Proposal of amendments to ECE/TRANS/WP.29/GRSP/2014/17

Proposal for amendments to global technical regulation No. 9
(Pedestrian safety)

Submitted by the expert from the European Commission as Chair of
the Task Force on Bumper Test Area within the Informal Working
Group on global technical regulation No. 9 Phase 2*

"Figure 5A

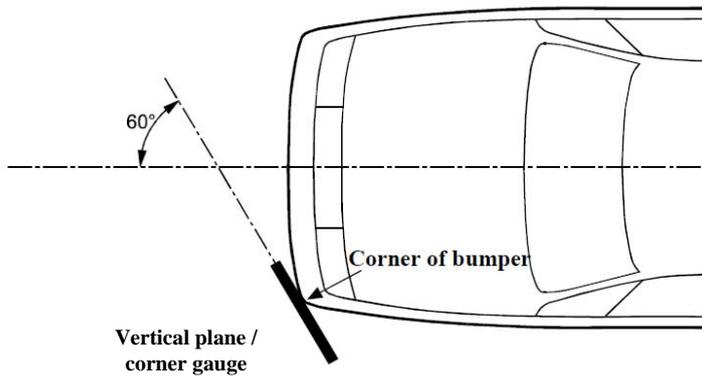
Figure 5, amend to read:

Corner of bumper example (see paragraph 3.13., note that the corner gauge is to be moved in vertical and horizontal directions to enable contact with the outer contour/
front fascia of the vehicle)

Figure 5B
Corner gauge

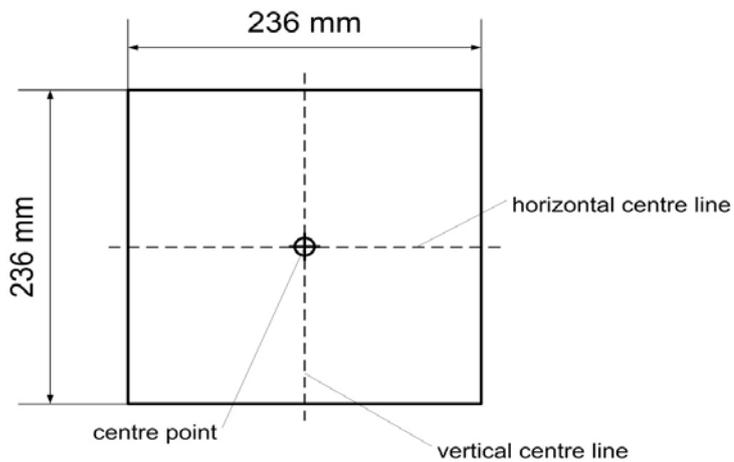
The front surface of the corner gauge is flat.

The centre point is the intersection of the vertical and horizontal centre lines on the front surface.

Figure 5C
 Determination of the corner of bumper with the corner gauge (shown in random location)

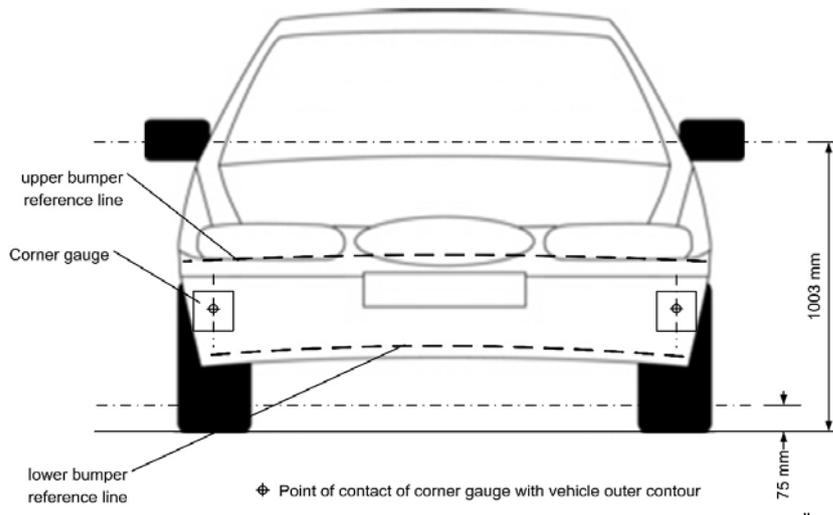
For determination of the corner of bumper, the front surface of the corner gauge is moved parallel to a vertical plane with an angle of 60° to the vertical longitudinal centre plane of the vehicle (see Figures 5A and 5C) at any height of the centre point of the corner gauge in the following area:
